HUNTERS POINT
LOTS 16 + 17
PROPOSED SEPTIC

PROPOSED SUBSURFACE WASTE DISPOSAL SYSTEM DETAIL SHEET

Regarding: Hunters Point, Lots 16+17. (4 pages)

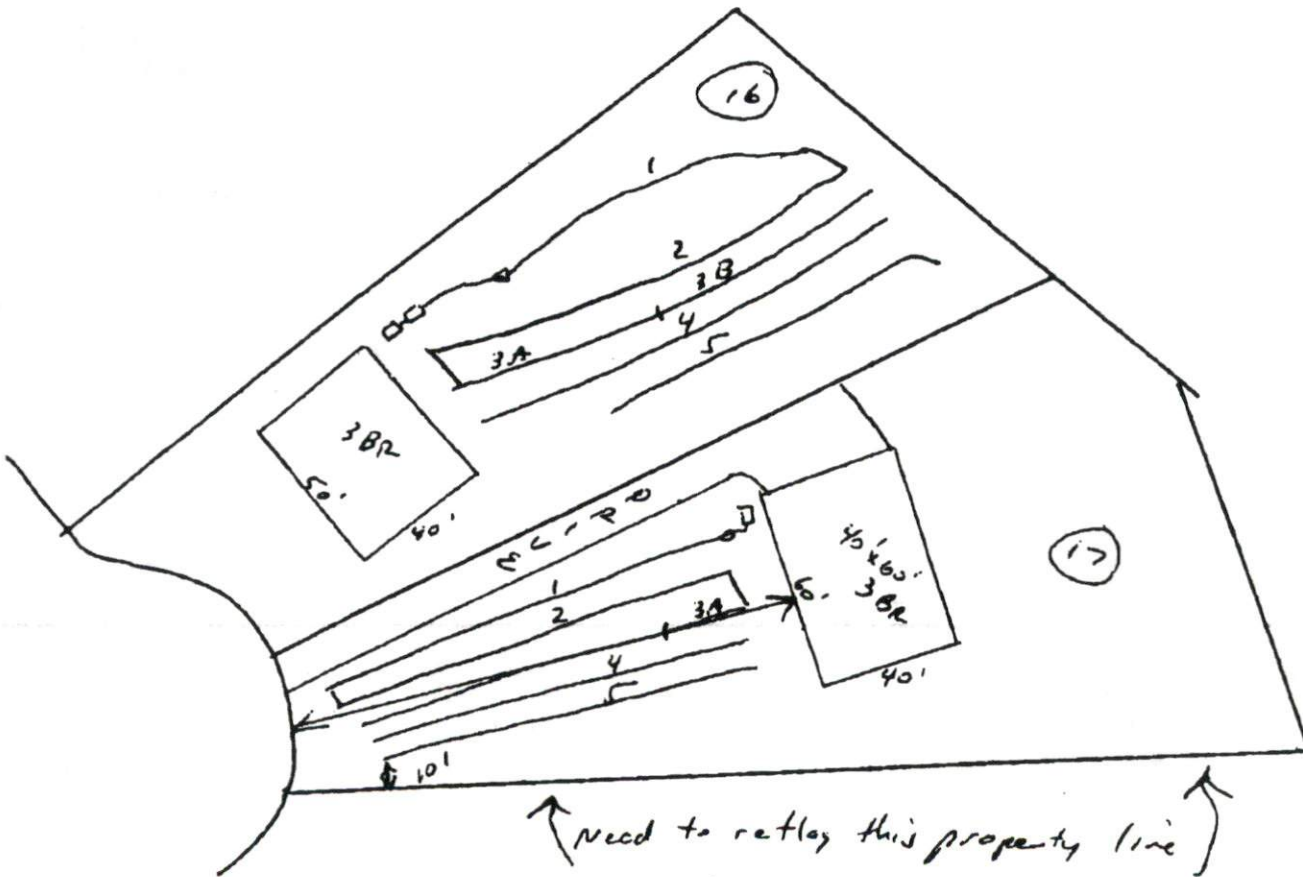
⊗ 142' HOUSE SETBACK ON LOT 17

- ① LOT 16 SHOULD BE APPROVED AS YOU PREVIOUSLY SUBMITTED
- * ② LOT 17 NEEDS TO BE REVISED WITH A 142' HOUSE SETBACK. YOU WILL ALSO NEED TO REFLAT LOWER PROPERTY LINE (AS SHOWN) TO VERIFY LOCATION. IT MAY NEED TO BE SLIGHTLY ADJUSTED TO MAINTAIN 10 FT. PLEASE SUBMIT NEW PLOT TO HARN CO.
- ③ I HAVE MET OLIVER (HARNETT CO) ON SITE AND RECEIVED APPROVAL FOR THESE DESIGNS.
